**CERTIFICATE OF APPROPRIATENESS**

**Property:** 2116 Chilton Road, Lot 24, Block 52, River Oaks Subdivision. The property includes a historic 5,056 square foot, two-story brick single-family residence situated on a 12,000 square foot interior lot.

**Proposal:** Alteration –Replace all non-original single-hung wood windows and non-original doors on the front and side elevations of the house. Original windows were replaced at an unknown time. The way the windows are glazed is how staff knows that they are non-original to the house.

**Recommendation:** Partial Approval: Approval to replace the front door; Denial for window replacement on the original house.

**SOUTH ELEVATION – FRONT FACING CHILTON ROAD**

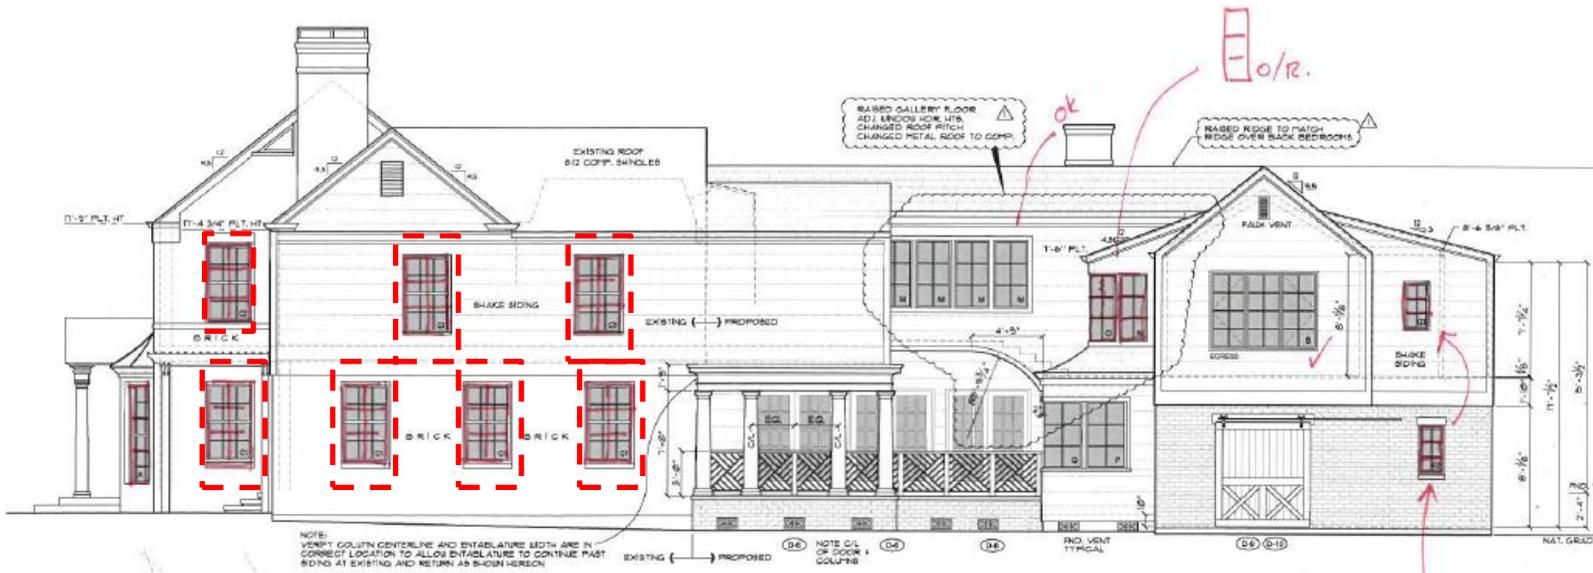
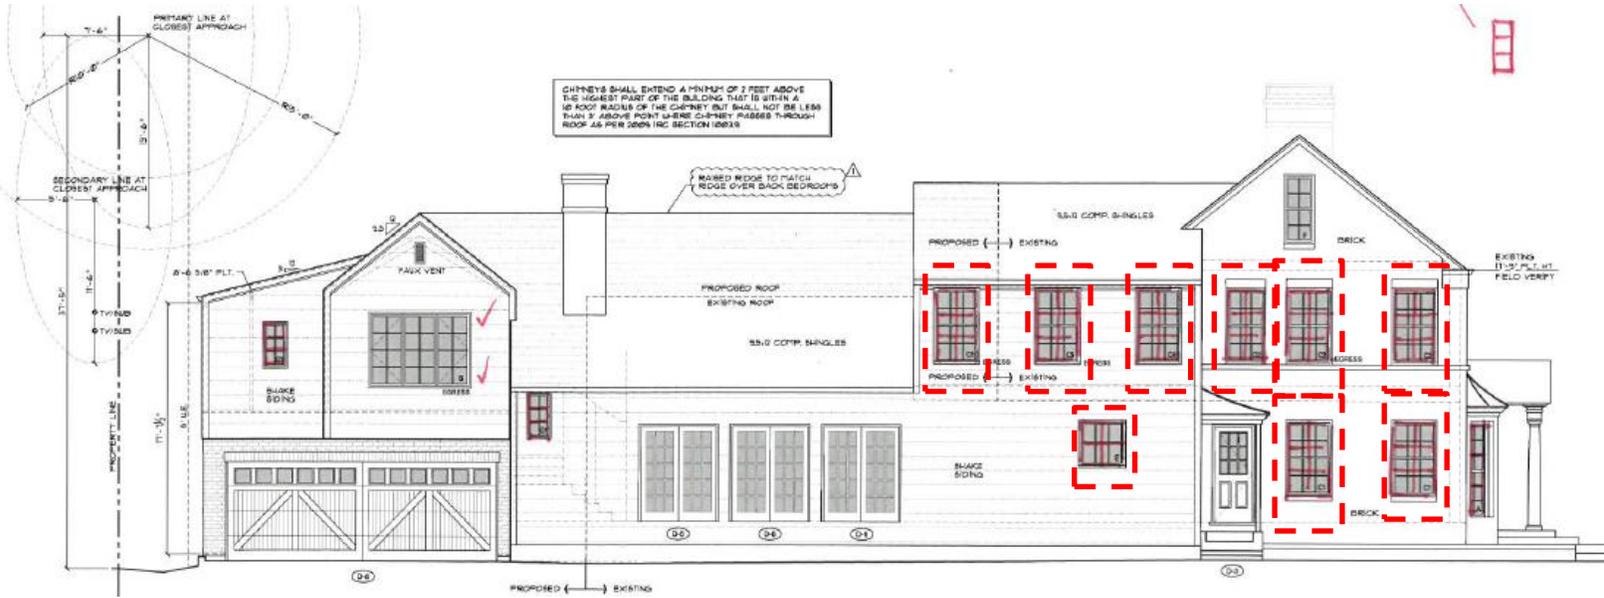
| <input type="checkbox"/> | <input checked="" type="checkbox"/> | <input type="checkbox"/>            | (1) The proposed activity must retain and preserve the historical character of the property;<br><i>The proposed more modern light configuration and material of the proposed windows is not compatible with what is found in the Colonial Revival architecture style. Lighting configuration that is present is compatible and should remain.</i>   |
| <input type="checkbox"/> | <input checked="" type="checkbox"/> | <input type="checkbox"/>            | (4) The proposed activity must preserve the distinguishing qualities or character of the building, structure, object or site and its environment;<br><i>Changing of the window will give the historic house a more modern appearance. Style and lighting configuration that is present should remain.</i>   |
| <input type="checkbox"/> | <input checked="" type="checkbox"/> | <input type="checkbox"/>            | (6) New materials to be used for any exterior feature excluding what is visible from public alleys must be visually compatible with, but not necessarily the same as, the materials being replaced in form, design, texture, dimension and scale;<br><i>Existing windows are wood and applicant is proposing vinyl windows.</i>   |

**HAHC Action:** Partially Approved: Approval to replace the front door; Denial for window replacement on the original house.
